APPLICATION NO.	FILING DATE	FIRST NAMED INVENTOR	ATTORNEY DOCKET NO.	CONFIRMATION NO.
10/556,659	10/10/2006	Shaun Burchell	1-17186	8569
1678	7590	10/16/2007		
MARSHALL & MELHORN FOUR SEAGATE, EIGHT FLOOR TOLEDO, OH 43604				
			EXAMINER SCHILLER, ALINA	
			ART UNIT 3671	PAPER NUMBER
			MAIL DATE 10/16/2007	DELIVERY MODE PAPER

Office Action Summary	Application No. 10/556,659	Applicant(s) BURCHELL, SHAUN	
	Examiner Alina Schiller	Art Unit 3671

DETAILED ACTION

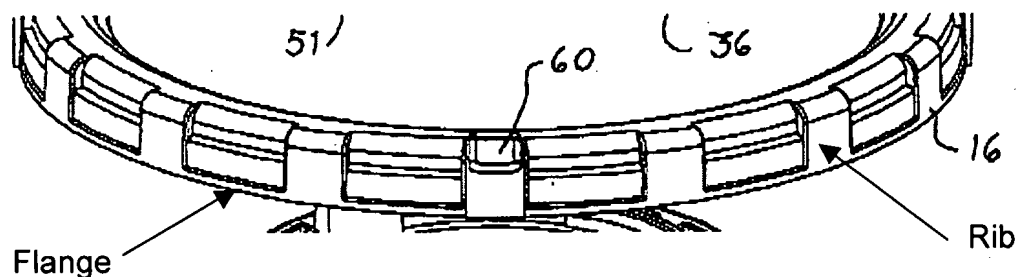
Regarding claim 19, Attar discloses a device as previously set forth, but fails to disclose that the lower edge of the shell carries an outwardly projecting flange to fix the marker against being pulled out of the road surface when the marker is embedded in

the road surface. Fleury teaches that the lower edge of the shell carries an outwardly projecting flange (as seen in the modified picture above), in order to better anchor the device into the road surface. It would have been obvious to one having ordinary skill in the art at the time the invention was made to modify the reflective road marker of Attar to have a flange on the lower edge of the shell, as taught by Fleury, in order to better anchor the device into the road surface.

Rib

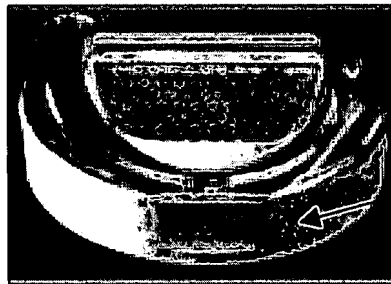
Regarding claim 18, Attar discloses a device as previously set forth, but fails to disclose that the shell has an operatively lower edge which includes a plurality of circumferentially spaced, externally projecting ribs to fix the marker against rotation when embedded in a road surface in use. In the Background of the Invention, the applicant discloses a currently popular embedded-type road marker (disclosed by the above-mentioned website), namely Armourstud, which shell has an operatively lower edge which includes a plurality of circumferentially spaced, externally projecting ribs (as seen in the modified picture below taken from the above-mentioned website). It would have been obvious to one having ordinary skill in the art at the time the invention was made to modify the device of Attar to have an operatively lower edge, which includes a plurality of circumferentially spaced, externally projecting ribs, as taught by the above-

mentioned website and disclosed by the applicant, in order to better engage the pavement around the borehole where the device is embedded.
